## Historic Architectural Review Commission Staff Report for Item 12

Application Number: C2026-0013

Address: 1320 Truman Avenue

**Minor Development Plan** – Demolition of non-contributing tennis pro shop, 3-tennis court complex shade structure and non-historic bathrooms.

*Proposed floor plan for one-story structure.*

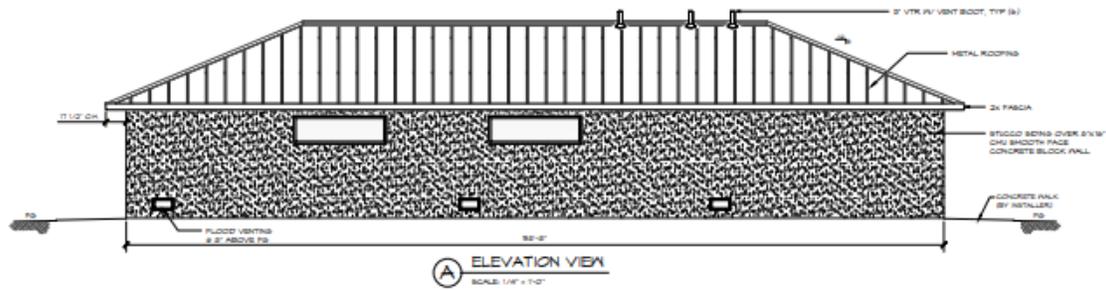
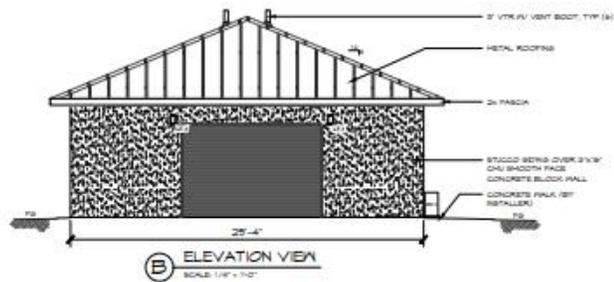
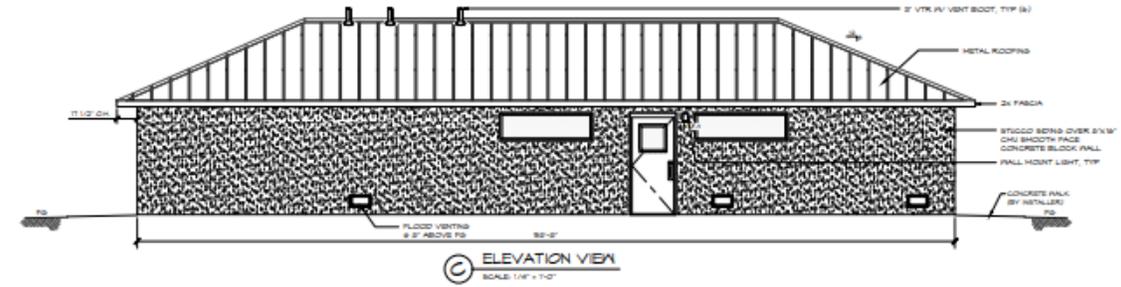
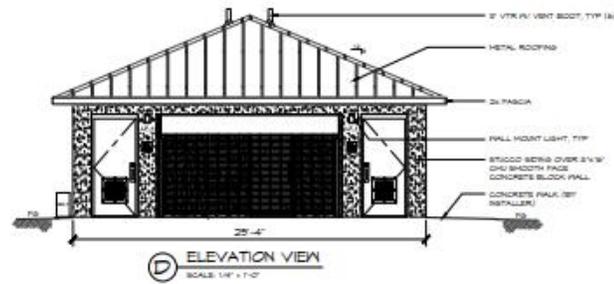
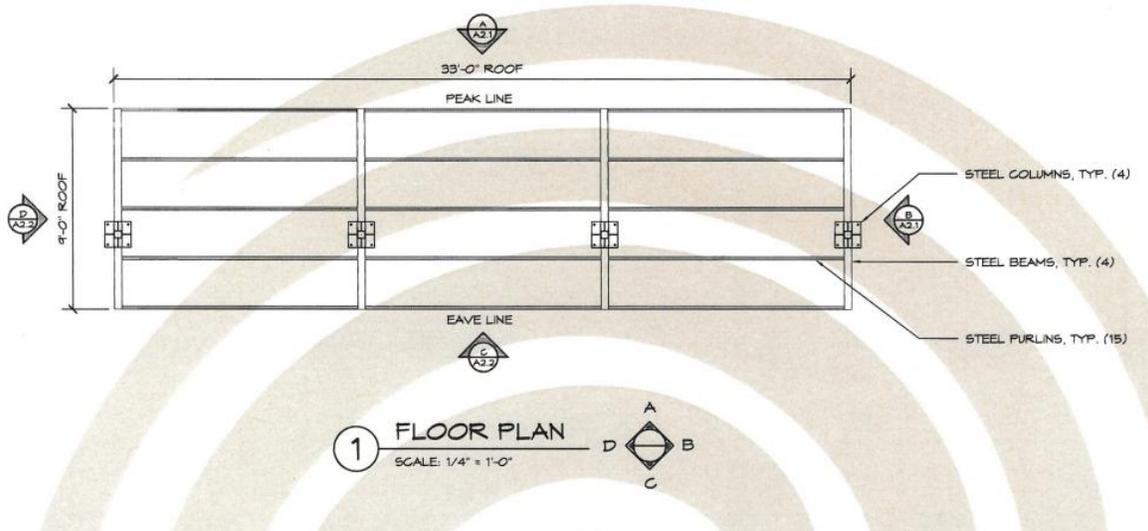
The proposed improvements are generally consistent with the HARC Guidelines. The new one-story structure is modest in scale and designed to support recreational uses within Bayview Park, housing a pro shop, restrooms, and storage. The use of a 5V-crimp metal roof and stucco exterior finish reflects materials commonly found in Key West and compatible with surrounding park structures. However, the elevation facing Truman Avenue is mostly solid with minimal openings. As this is a highly visible frontage, the HARC Guidelines for New construction encourage appropriate openings and articulation (*Guidelines 7 and 25*), and the current design appears very plain.

*Proposed floor plan for shade structure.*

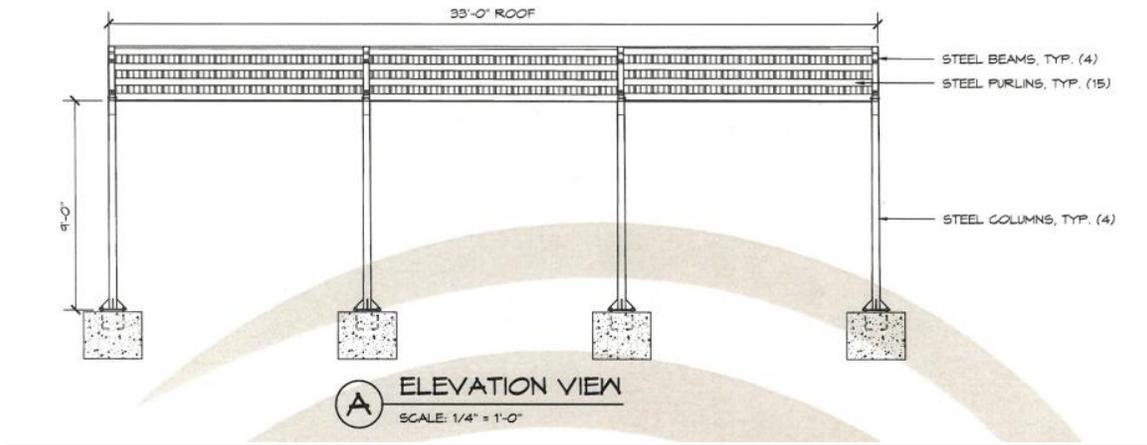
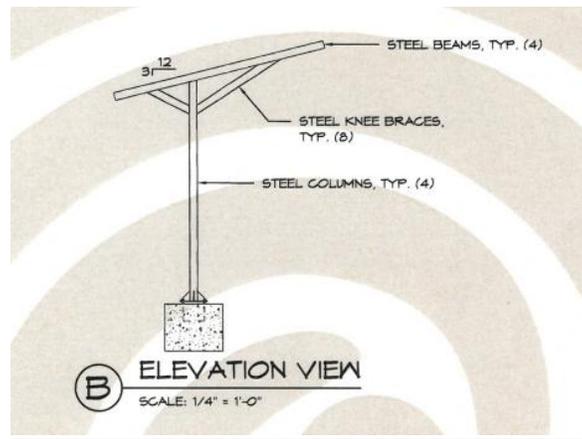
The proposed shade structure will be located in the same area as the existing tennis court shade structure. Its steel framing and metal roof are typical for recreational facilities and remain subordinate to the surrounding area. Additional site improvements, including bike repair stations and bike racks. This proposal represents Phase 2 of the Bayview Park improvements, following Phase 1 from June 2025.
